SUBMISSION - NORTHCONNEX

NorthConnex EIS Submission

NorthConnex Application Number: SSI 13_6136

Figure 9 Predicted tunnel traffic flows – northbound

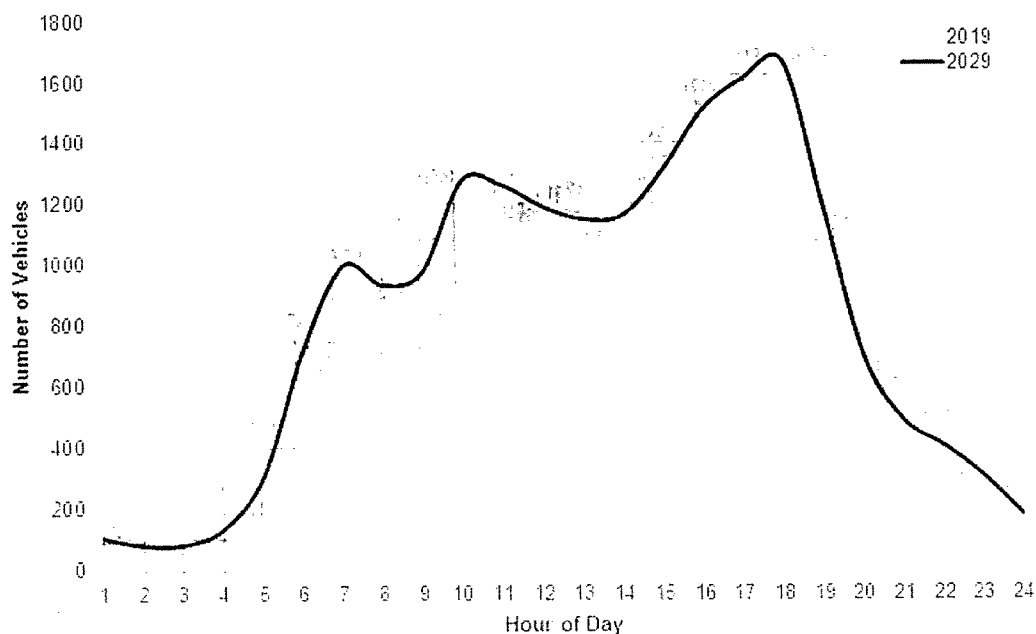
NorthConnex Project overview clearly states that the NorthConnex would take 5,000 trucks off Pennant Hills Road each day, and it would have capacity to carry more than 100,000 vehicles per day (50,000 in each direction). However the EIS emission calculation misleadingly used the figure of 19,500 vehicles per day per direction as the basis for their calculation. Refer to Appendix A for the handwritten calculations in relation to the EIS "Predicted tunnel traffic flow –northbound" in 2029.

In my professional opinion, the EIS vehicle emission has been underestimated by using the figure of 19,500 daily vehicles in lieu of 50,000 daily vehicles. Therefore, the purported EIS calculation is not only unreliable but raises the concern whether it accurately includes the "5,000 [daily] trucks off Pennant Hills Road".

NOTE: A SUMMARY OF UNDER SHARED DATA FOR 2019 = 19500 VEHICLES/DAY
WHICH IS FAR LESS THAN THE TUNNEL CAPACITY 50,000 VEHICLE/DAY

SECTION A-A
AT 'CUT & COVER' TUNNEL
1:200

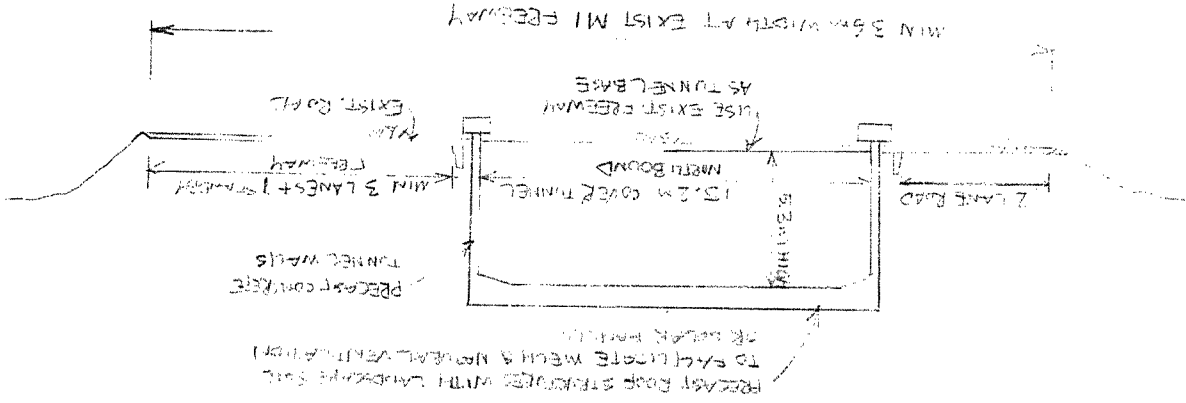
Importantly, I would like to propose an alternative 'cut & cover' tunnel extension & relocate Northbound portal & stack into bush land & industrial zone, please find the attached "Appendix E- Alternative 'Cut & Cover' Tunnel" design sketch for your consideration. I have briefly listed some advantages of my alternate design below:

- Existing freeway at North Wahroonga has sufficient minimum 36m width to accommodate the 'cut & cover' tunnel in the middle of aisle as shown on section A-A, and provide advantage to access tunnel at side walls for all fire emergence(EIS does not consider currently).
